Architectural Drawings SSDA RtS

2b-6 Hassall Street
Parramatta

Charter Hall and Western Sydney University

August 2019

Sheet Name
SECTION B

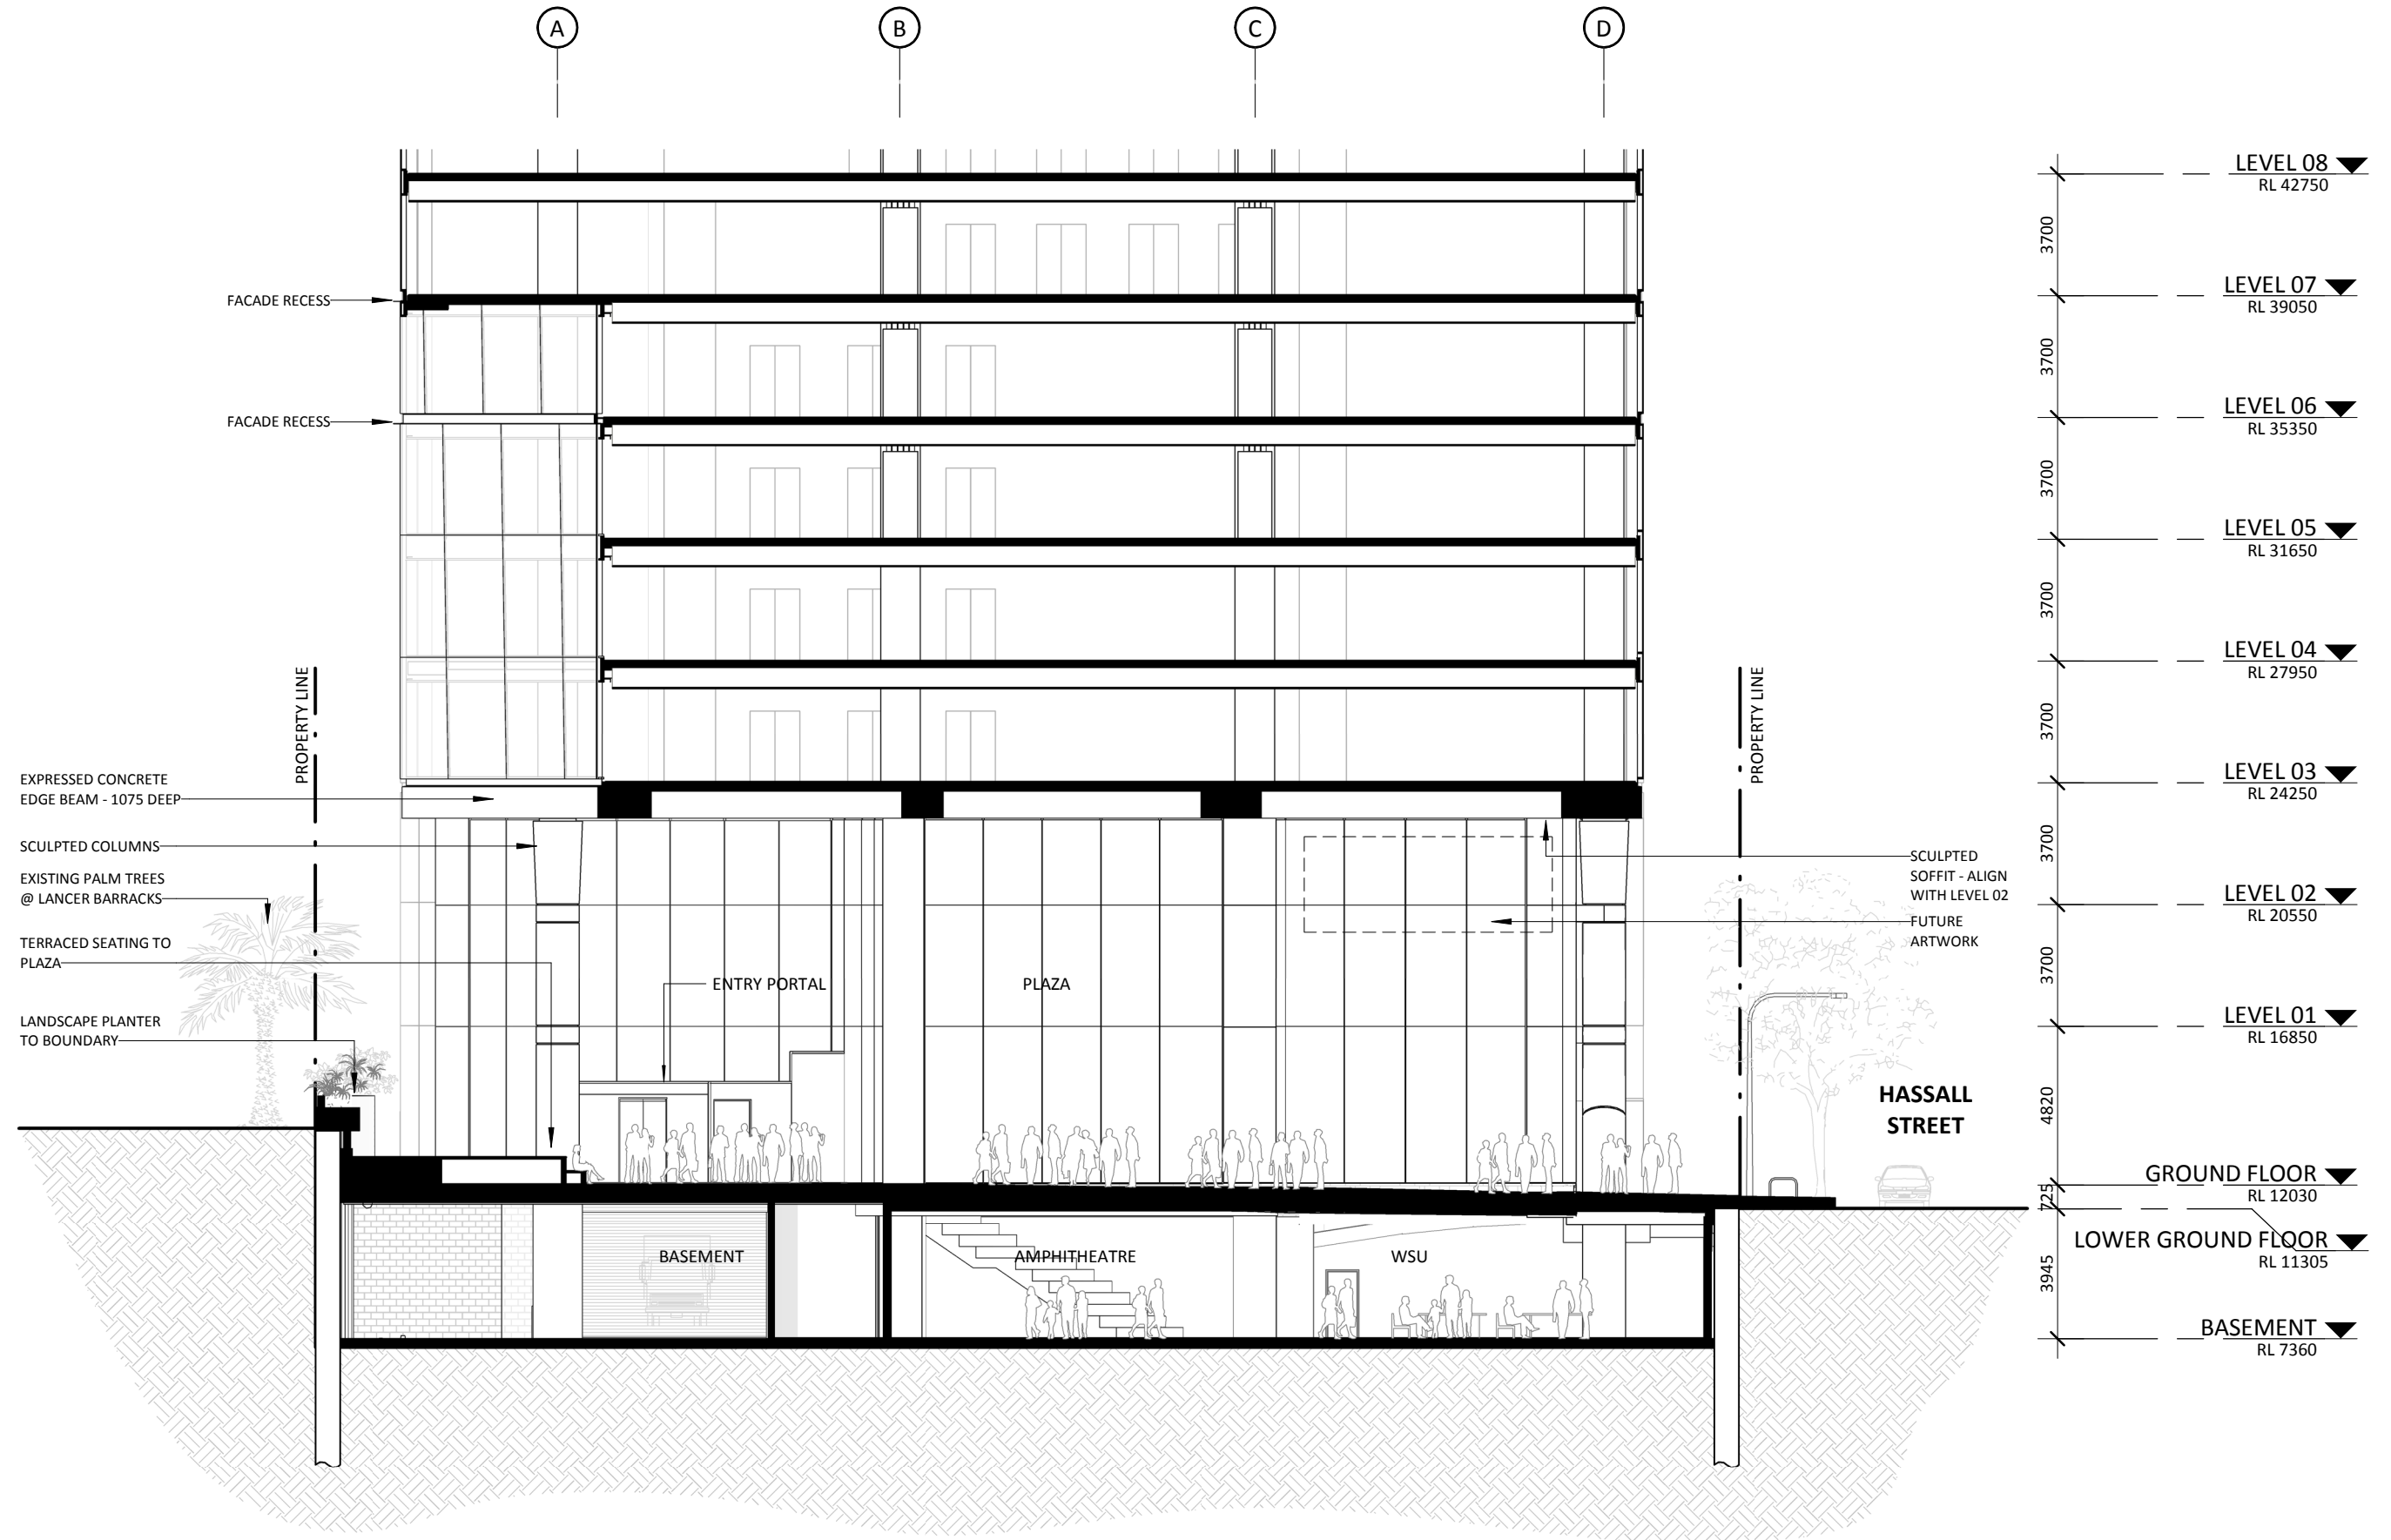
LEVEL/ DRAWING NO.	CLOUD NO.	CHANGE DESCRIPTION	CORRESPONDING EU RESPONSE SCHEDULE NO.
SECTION A/ 20.00 SECTION B/ 20.01 NORTH ELEVATION/ 30.00 EAST ELEVATION/ 30.01 SOUTH ELEVATION/ 30.02 WEST ELEVATION/ 30.03	17	Lift over-run height adjusted	-
	18	Floor to floor height adjusted to allow flush threshold access to L12 terrace	CoP 4a
	19	Façade finishes schedule updated	-
	20	Building height rationalised	-
	21	Proposed height of cooling tower enclosure	-
	22	- Core finishes clarified to allow for flexibility of construction - Finish to be precast concrete panels and/or off form concrete	-
	23	Horizontal louvre for general exhaust added	-
TYPICAL TERRACE DOOR DETAILS / 52.05	24	Threshold details added	CoP 4a
EXTERNAL FINISHES SCHEDULE/ 60.01	25	See Cloud No. 22	-
